DESCRIPTIVE REPORT

Registry No. H-10972

General Locality Taiya Inlet

Sublocality Skagway

Figure 2: Prior Surveys in Common with H10972

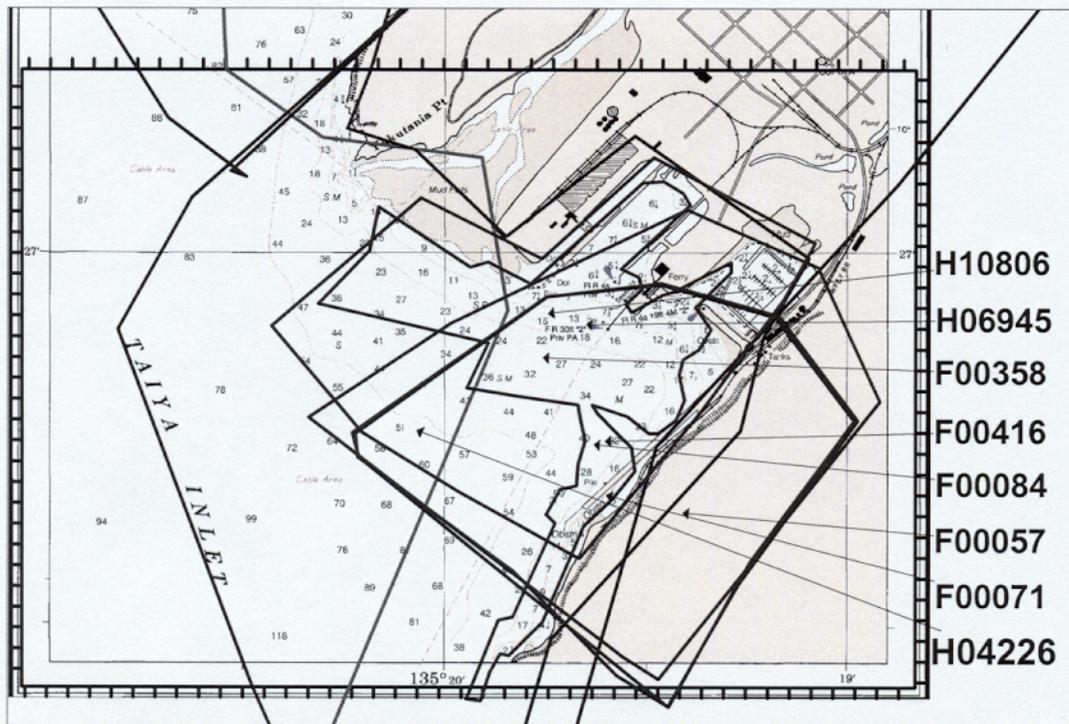
Prior survey H10806 covers the entire area of present survey H10972. Comparison of depths reveals the present and prior survey generally differ by less than one fathom⁵⁴, except in the vicinity of the White Pass and Yukon Corporation commercial pier where the present survey is generally four to five⁵⁵ fathoms deeper than the prior survey. The present differences in depths may be attributed to the improved sounding methods and relative accuracy of the data acquisition process utilized during the present survey.⁵⁶

Prior survey H10806 reported a submerged steel pipe located at 59° 26' 50.79" N, 135° 19' 23.46" W. No further investigation on this obstruction was warranted during this survey since it was sufficiently addressed in 1998. This area has 100% multibeam coverage, with the present survey depths agreeing with the prior depths. The Hydrographer recommends retaining the submerged obstruction.⁵⁷

⁴⁷ Prior surveys H-10806 and F00358 are the sole source data for the current chart in common with the present survey. The present survey was compared to a digital copy of H-10806 which includes prior survey data brought forward from F00358. The registration and legibility of this digital copy to the present survey work was good. Differences in depths generally range from 0-2 fathoms throughout the survey area and reflect no consistent bias of shoaling and or an increase in depths. The greatest depth discrepancies with the prior survey (2-4 fathoms) are seen in isolated areas offshore of the White Pass and Yukon Corporation's commercial wharf where the bottom slopes off rapidly into the harbor. Present survey depths in the small boat marina reflect very little change since 1990. Depth differences are largely attributed to the recent cultural activity within Skagway Harbor. The use of different sounding collection systems may account for some differences along the more steeply sloping bottom areas.

With the exception of a few soundings and features transferred from the prior surveys, survey H-10972 is adequate to supersede the prior work within the common area.

| ⁴⁸ PHB Revision-Strikethrough | H04226 | 1:40,000 | 1922 | Valdez |
| ⁴⁹ PHB Revision-Strikethrough | H06945 | 1:2,000 | 1943 | NAD27 |
| ⁵⁰ PHB Revision-Strikethrough | F00057 | 1:1,000 | 1945 | NAD27 |
| ⁵¹ PHB Revision-Strikethrough | F00071 | 1:2,000 | 1948 | NAD27 |
| ⁵² PHB Revision-Strikethrough | F00084 | 1:2,000 | 1950 | NAD27 |

⁵³ PHB Revision-Strikethrough ~~F00416~~ ~~1:5,000~~ ~~1995~~ ~~NAD83~~

⁵⁶ Concur with clarification. Depth differences are largely attributed to the recent cultural activity within Skagway Harbor. The use of different sounding collection systems may account for some differences along the more steeply sloping bottom areas. Additional information is found in the hydrographer's report, section D.6.
